Wisconsin Department of Transportation

Proposal #10: 1228-09-73, WISC 2022200
IH 43 North South Freeway
Mitchell I/C to Marquette I/C
IH 43
Milwaukee County

This is Addendum No. 01, which provides for the following:

ADDENDUM NO. 01

Addendum No. 01
 ID 1228-09-73
 Revised Sheet 19
 January 28, 2022

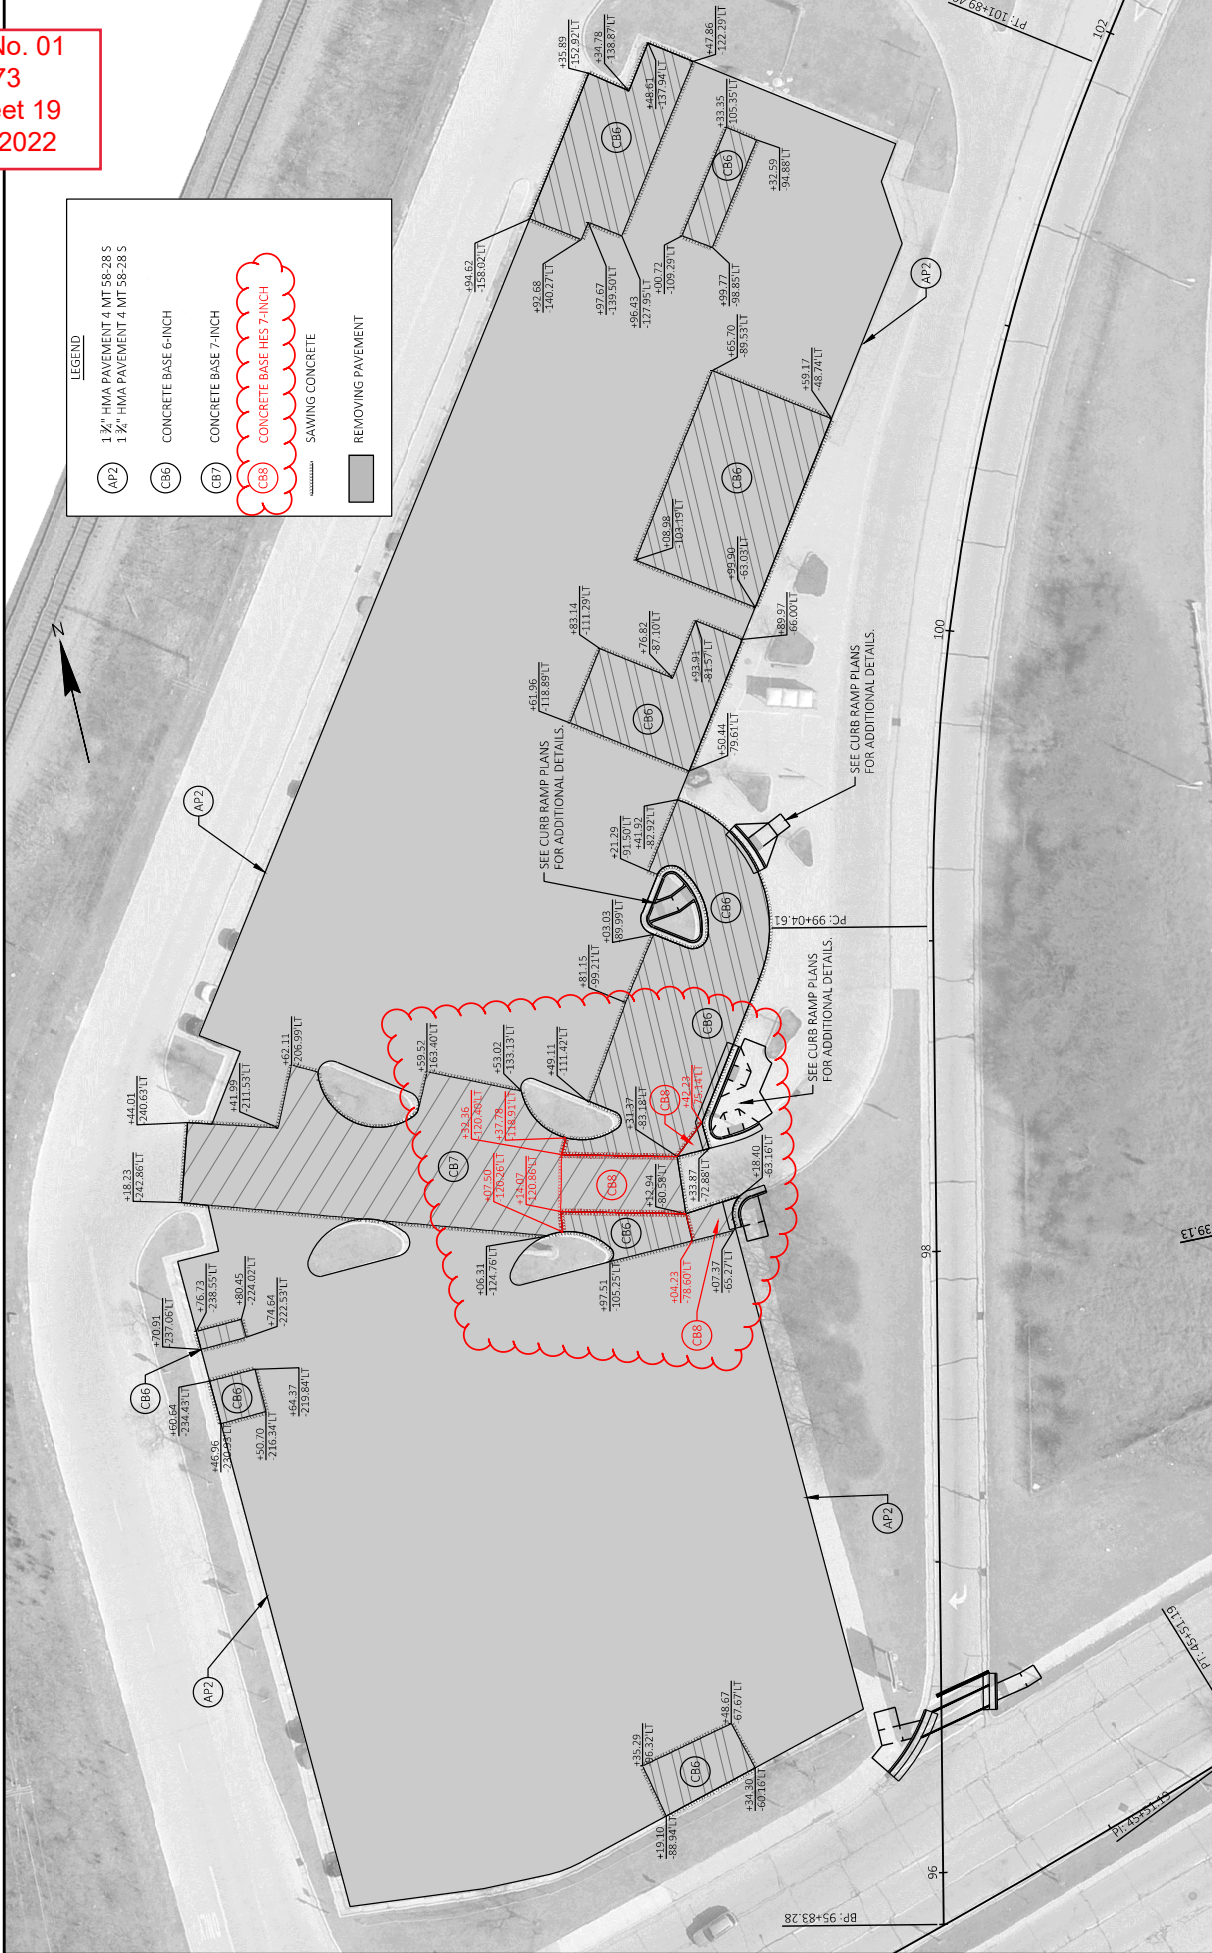
Revised Plan Sheets	
Plan Sheet	Plan Sheet Title (brief description of changes to sheet)
19	Revision to concrete pavement
362	Miscellaneous Quantities – Update to drilled dowel bars, drilled tie bars and sawing concrete quantities
363	Miscellaneous Quantities – Concrete barrier delivered and installed
373	Miscellaneous Quantities – Addition of roadside clearing, clearing and grubbing quantities
525	Structure plans – B40-174 – The old plan from 2012 was inserted incorrectly.
526	Structure plans – B40-174 – The old plan from 2012 was inserted incorrectly.
527	Structure plans – B40-174 – The old plan from 2012 was inserted incorrectly.
528	Structure plans – B40-175 – Rapid set deck repair replaces concrete masonry deck repair
532	Structure plans – B40-177 – Rapid set deck repair replaces concrete masonry deck repair
534	Structure plans – B40-177 – Rapid set deck repair replaces concrete masonry deck repair

Addendum No. 01
 ID 1228-09-73
 Added Sheet 19A
 January 28, 2022

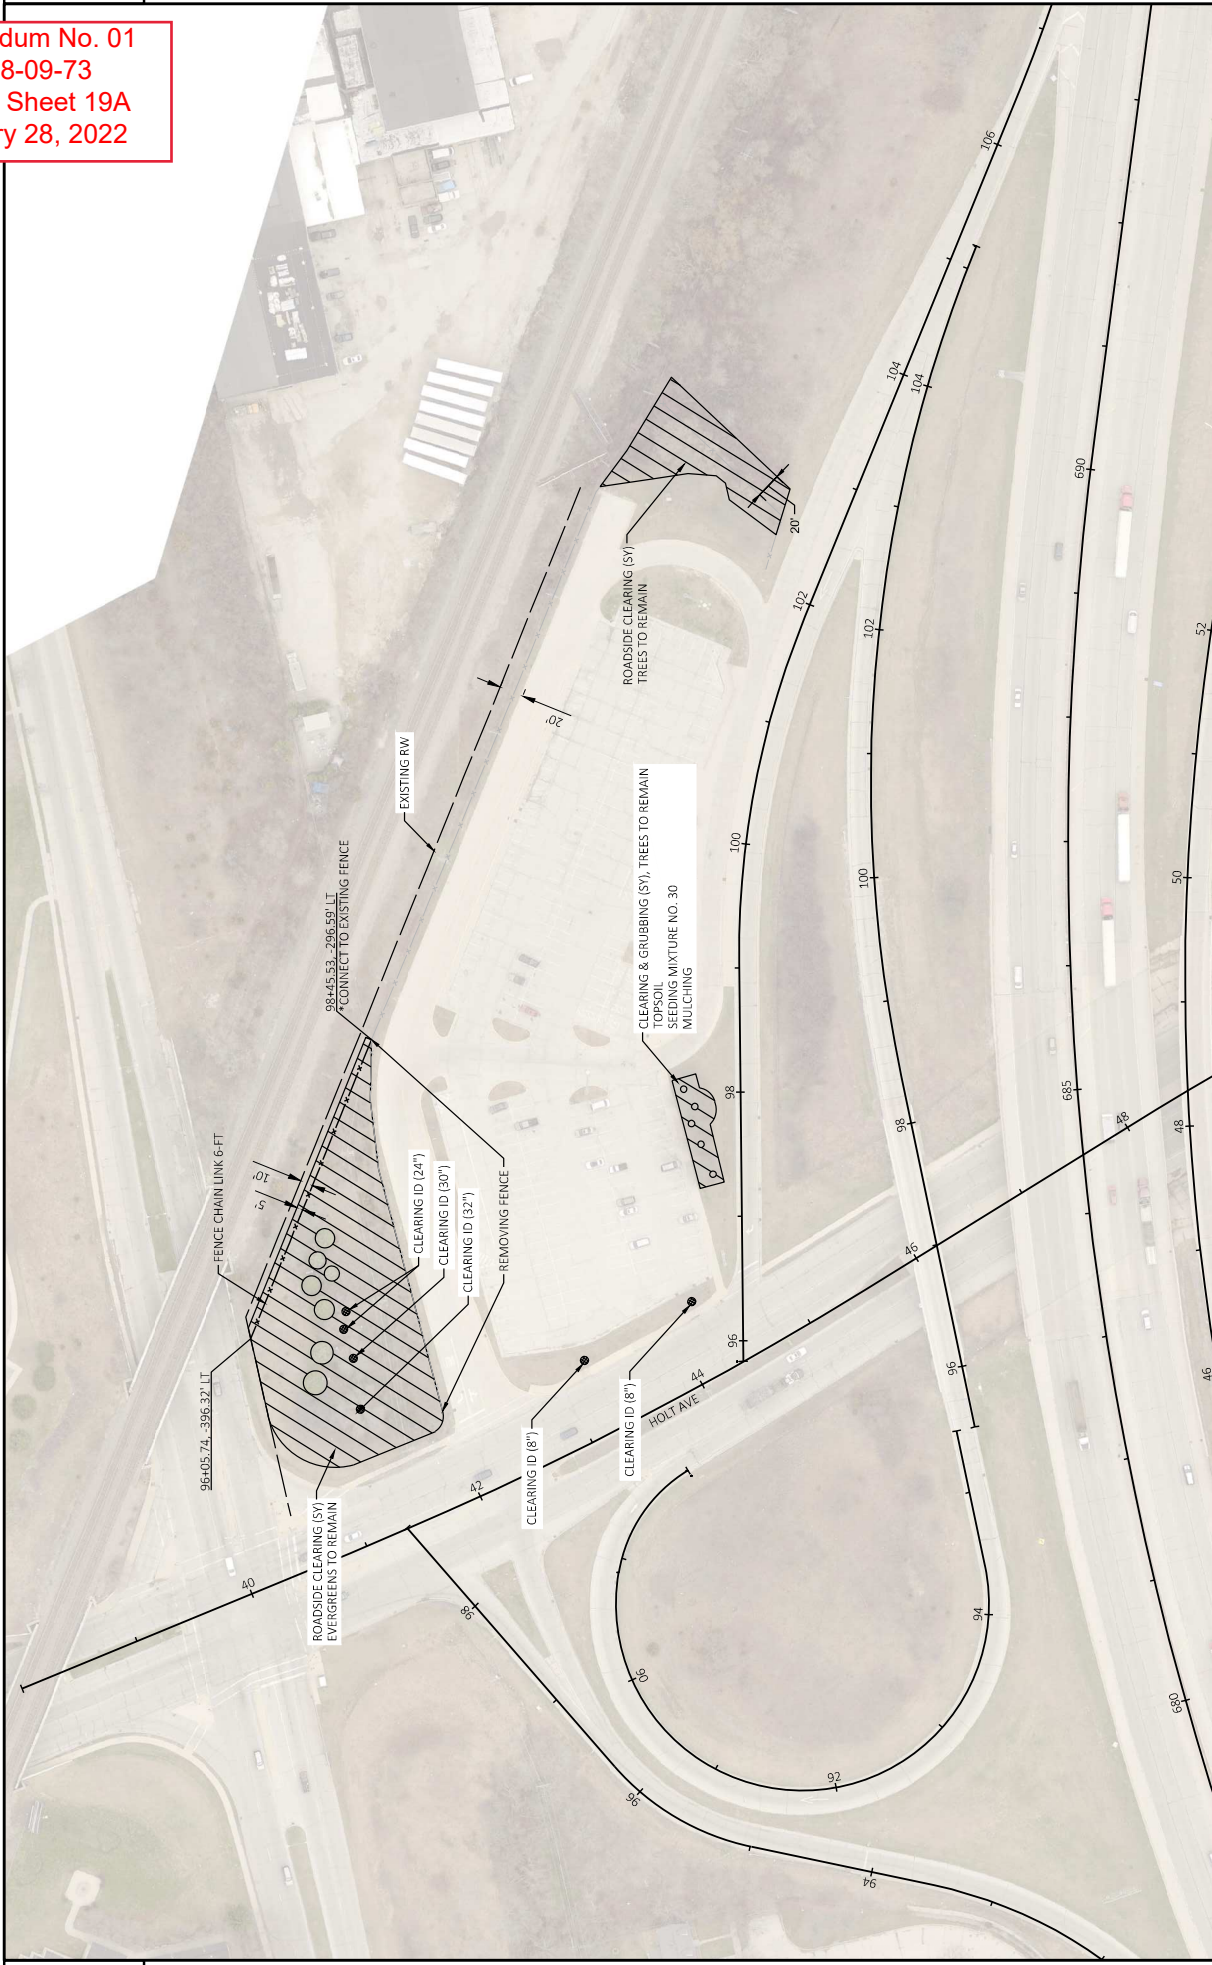
Added Plan Sheets	
Plan Sheet	Plan Sheet Title (brief description of why sheet was added)
13A	Construction Detail – Added for clarification
15A	Construction Detail – Added for clarification
19A	Construction Detail – Added clearing and fence removal / replacement at park and ride
374A	Miscellaneous Quantities – Addition of fence removal and replacement at park and ride

Addendum No. 01
ID 1228-09-73
Revised Sheet 528
January 28, 2022

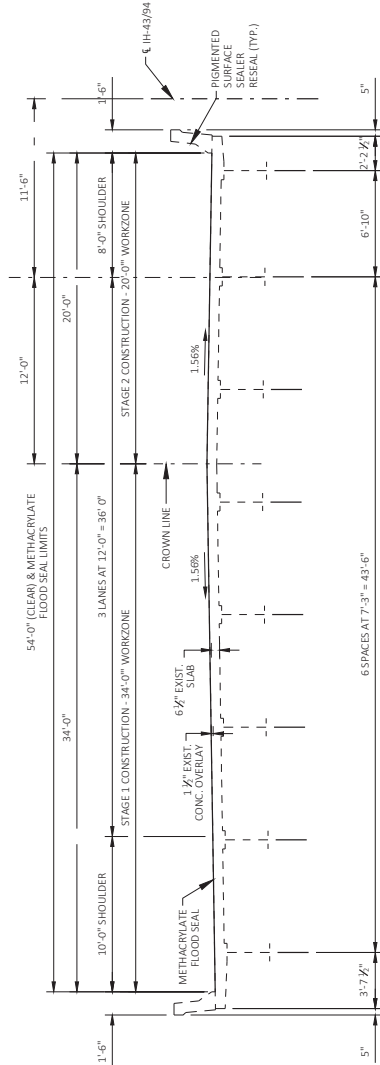
NO.	DATE	REVISION	BY
1	1/26/22	ADDITION OF SPV.0035.0001	JCG

RAPID SET DECK REPAIR
CONCRETE MASONRY - SURFACE REPAIR
f_c = 3,000 P.S.I. - 3 HOURS
f_c = 4,000 P.S.I.

Addendum No. 01
ID 1228-09-73
Revised Sheet 534
January 28, 2022

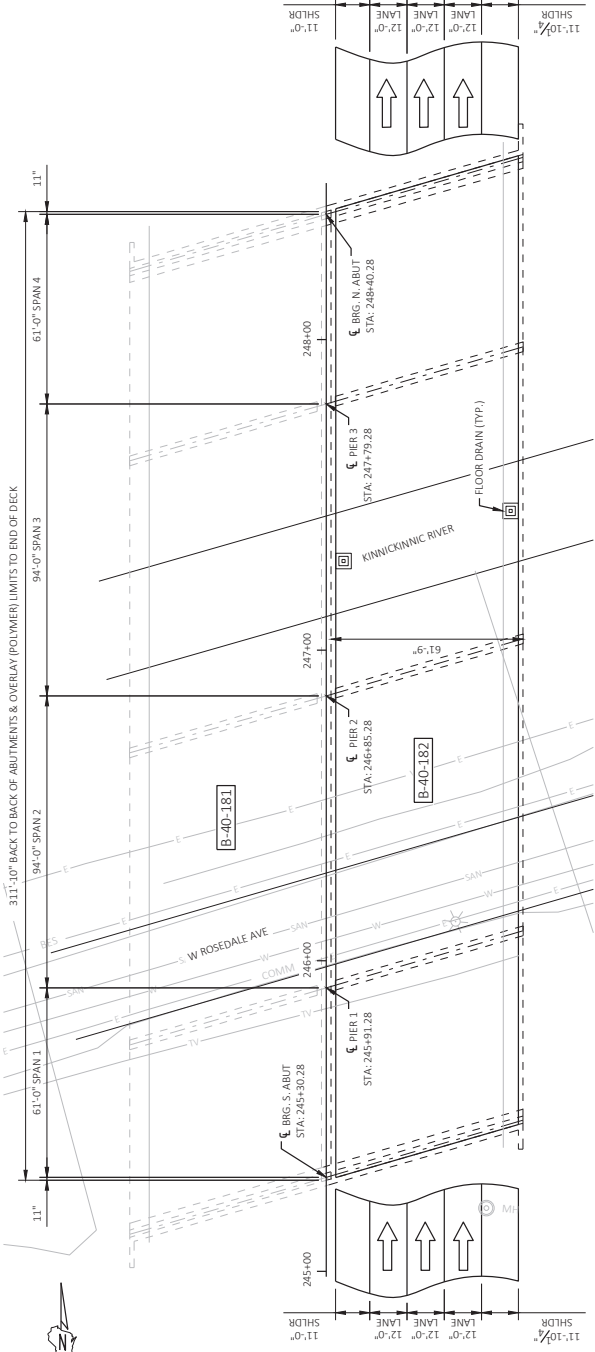
NO.	DATE	REVISION	BY
1	1/26/22	ADDITION OF SPV.0035.0001	JCG

CARDO SET DECK REPAIR
CONCRETE MASONRY: SURFACE REPAIR
f_c = 3,000 P.S.I. (10000)
f_c = 4,000 P.S.I.

Addendum No. 01
ID 1228-09-73
Revised Sheet 546
January 28, 2022

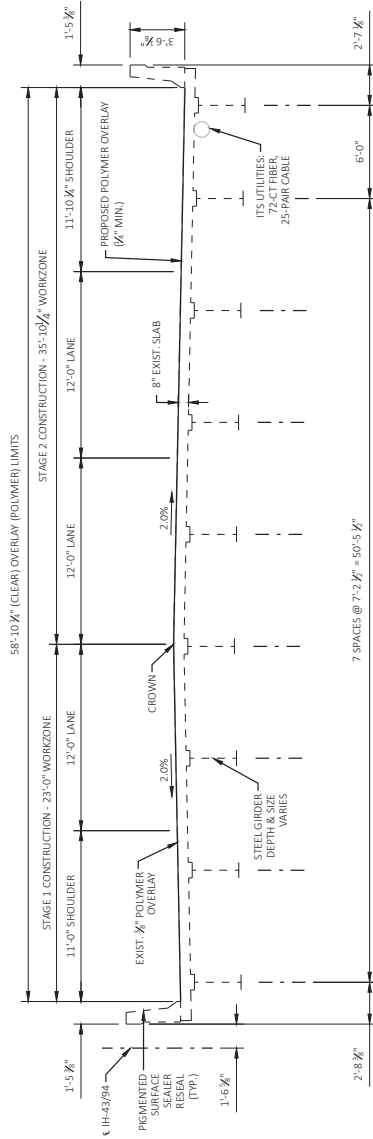
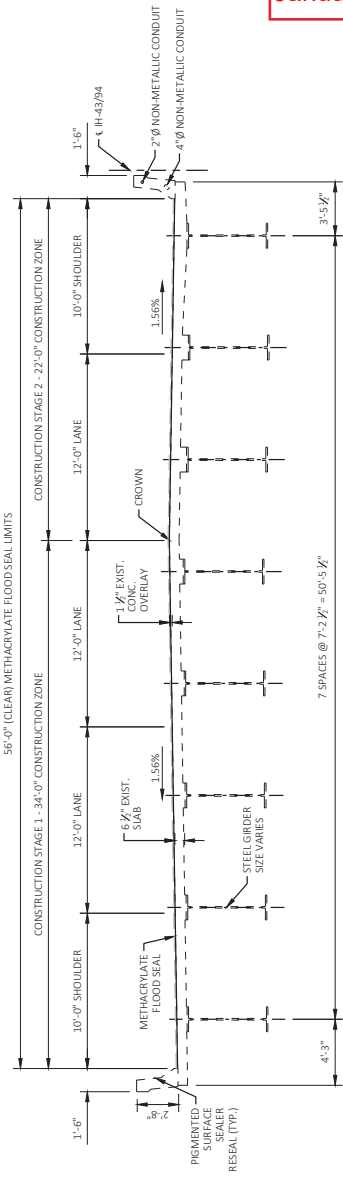
545	Structure plans – B40-182 – Rapid set deck repair replaces concrete masonry deck repair
546	Structure plans – B40-182 – Rapid set deck repair replaces concrete masonry deck repair
548	Structure plans – B40-183 – Rapid set deck repair replaces concrete masonry deck repair
556	Structure plans – B40-261 – Rapid set deck repair replaces concrete masonry deck repair
557	Structure plans – B40-261 – Rapid set deck repair replaces concrete masonry deck repair
604	Structure plans – B40-286-24B – Fence bid item change
606	Structure plans – B40-286-24B – Fence bid item change

NO.	DATE	REVISION	BY
1	1/26/22	ADDITION OF SPV.0035.0001	JCG

RAPID SET DECK REPAIR
CONCRETE MASONRY SURFACE REPAIR
fc = 3,000 P.S.I., 3 HOURS
fc = 4,000 P.S.I.

Addendum No. 01
ID 1228-09-73
Revised Sheet 557
January 28, 2022

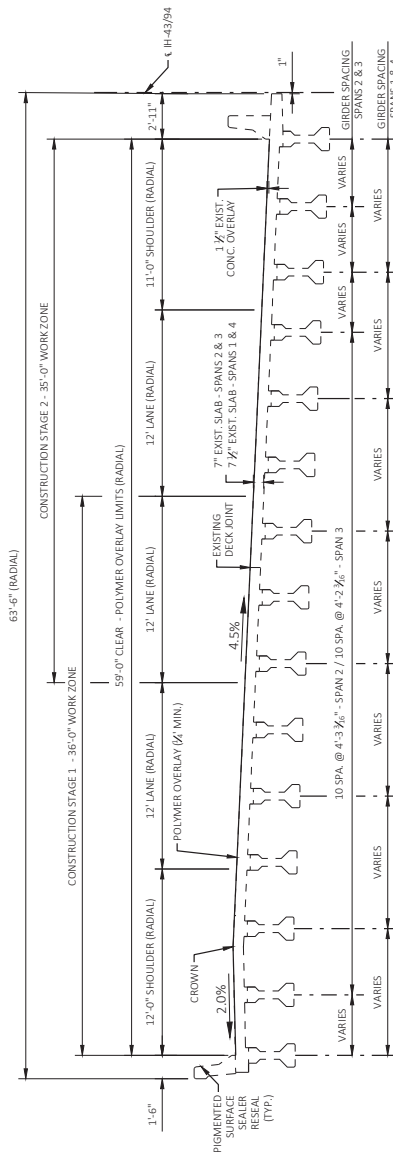
NO.	DATE	REVISION	BY
1	1/26/22	ADDITION OF SPV.0035.0001	JCG
STATE OF WISCONSIN DEPARTMENT OF TRANSPORTATION STRUCTURES DESIGN SECTION			
STRUCTURE B-40-261			
DRAWN BY MDS		PLATE NO. 1003	JCG
CROSS SECTION & QUANTITIES			SHEET 2 OF 3
			557
